## Technical Data Report Error Resolution Document

| 1. Originator:<br>Paul W. Reimus/Ming Zhu                  | 2. Date:<br>4/11/08                                   | 3. ERD No.<br>TDR-CRW-GS-000001 ERD 01 |
| 4. Document Identifier:<br>TDR-CRW-GS-000001 REV 02 ICN 01 | 5. Document Title:<br>Yucca Mountain Site Description |                                        |

Revisions to Figures and Tables of TDR-CRW-GS-000001 REV 02 ICN 01

Figure 3-21[a]. East-West Structure Section across Yucca Mountain Site Area [Addresses CR 2656, comment 23]

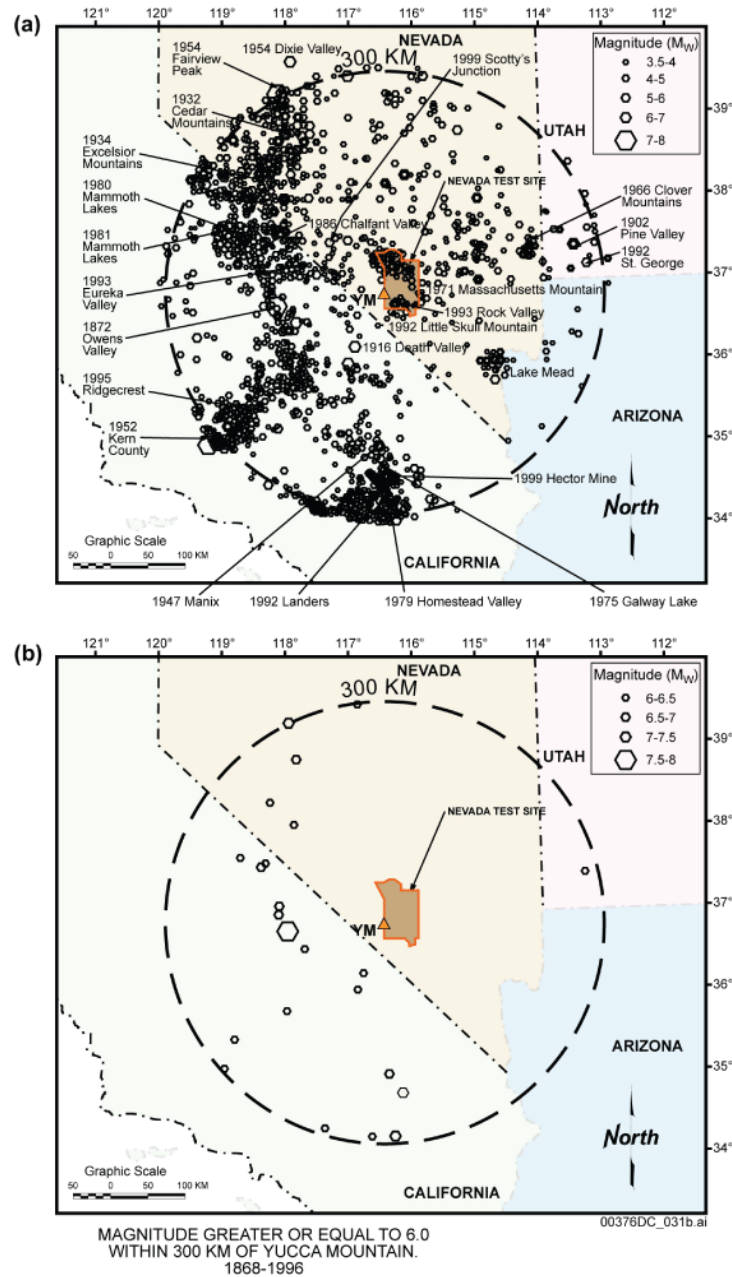
- (comment 23 of updated CR 2656 list) The label “Solitario Canyon-Bow Ridge/Paintbrush Canyon” in Figure 3-21 should be changed to just “Solitario Canyon-Bow Ridge”. See revised figure in Attachment A.
- (comment 25 of updated CR 2656 list) In Section 3.4.6.4, p. 3-57, the statement that the maximum and mean depths of erosion in the study area were about 1.8 m and 5 cm (6 and 1.6 ft), respectively, should be changed to “1.8 m and 5 cm (6 and 0.16 ft), respectively.” 5 cm is equal to 0.16 ft, not 1.6 ft.
- (License Application review comment added to most recent version of the CR 2656 list) In Section 7.9.1.2, p. 7-100, in the 5<sup>th</sup> line of this section, “TSw” should be changed to “TCw”. Also, the reference to Section 7.3 in the 7<sup>th</sup> line of this section should be changed to Section 7.3.2.1.

Figure 4-18[a]. Historical Earthquake Epicenters within 300 km of Yucca Mountain [Addresses CR 2656, comments 1, 2, 3, 4, 5, 6, 7, and 13]

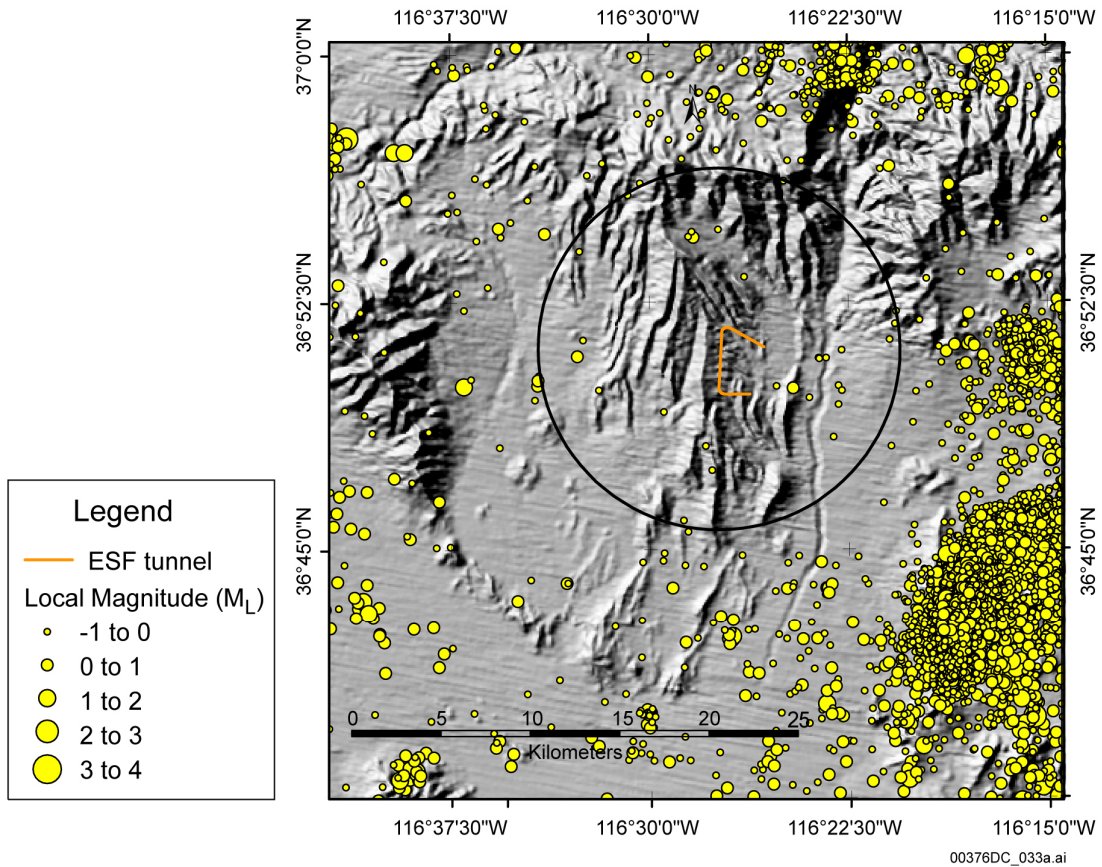
- (1) In Figure 4-18, “Galaxy Lake” should be “Galway Lake”. See figure revision in Attachment A.
- (2) In response to a comment about the Kern County and Dixie Valley earthquakes being inconsistently presented in Figure 4-18 and Table 4-8, and also being more than 300 km from Yucca Mountain (contrary to what the figure caption and table title state), the Dixie Valley earthquake should be deleted from the table and from part (b) of the figure, and the following should be added to the figure caption: “In (a), although they lie more than 300 km from Yucca Mountain, the 1954 Dixie Valley earthquake ( $M_w$  6.8) and the 1952 Kern County earthquake ( $M_w$  7.5) are shown because of their historical and seismological significance.” See figure revision in Attachment A.

- (3, 4, 13) In response to two comments that Table 4-8 includes the 1999 Scotty’s Junction and 1999 Hector Mine earthquakes, and that the 1999 Hector Mine earthquake is discussed in the text but does not appear in Figure 4-18, these two earthquakes should be added to Figure 4-18. Note that there is an incorrect statement in comment (3) indicating that Figure 4-18 shows seismicity occurring in 1997 and 1998 as well as the Hector Mine event. The figure does not show seismicity occurring in 1997 and 1998, although the Hector Mine event has been added to the figure. See figure revision in Attachment A.

- (5, 7) In response to two comments that “significant” is not defined in the context of earthquake magnitude, the Table 4-8 title should be changed to “Earthquakes with  $M_w$  Greater than 5.0 within 300 Kilometers of Yucca Mountain”, and “Significant earthquakes” in the Figure 4-18 caption should be changed to “Earthquakes of note”. See figure revision in Attachment A.

- (6) In response to a comment that the text mentions that Figure 4-18 shows seismicity that occurred in 1997 and 1998, but Figure 4-18 only shows events through 1996, the following sentence should be deleted from p. 4-32: “The figure also shows seismicity that occurred in 1997 and 1998 and the earthquakes associated with the 1999 Hector Mine event, which had a magnitude of  $M_w$  7.1.” The figure does not show seismicity occurring in 1997 and 1998, although the Hector Mine event has been added to the figure. The inclusion of the Hector Mine event should be mentioned in the figure notes, so that there is no need to mention it in the text at this location. See figure revision in Attachment A.

NOTES: Shown are earthquakes from 1868 to 1996, plus the 1999 Scotty's Junction and Hector Mine events. This seismicity catalog was compiled from a variety of sources. Coverage of older seismicity is sparse because of the absence or limited availability of seismographic coverage in the late 1800s and early 1900s. The cluster of earthquakes near the southern boundary of the Nevada Test Site represents the 1992 Little Skull Mountain earthquake and its numerous aftershocks. Many of the events in the northern part of the Nevada Test Site occurred in response to underground nuclear weapons tests. Earthquakes of note are labeled with year of occurrence. In (a), although they lie more than 300 km from Yucca Mountain, the 1954 Dixie Valley earthquake (M<sub>w</sub> 6.8) and the 1952 Kern County earthquake (M<sub>w</sub> 7.5) are shown because of their historical and seismological significance.
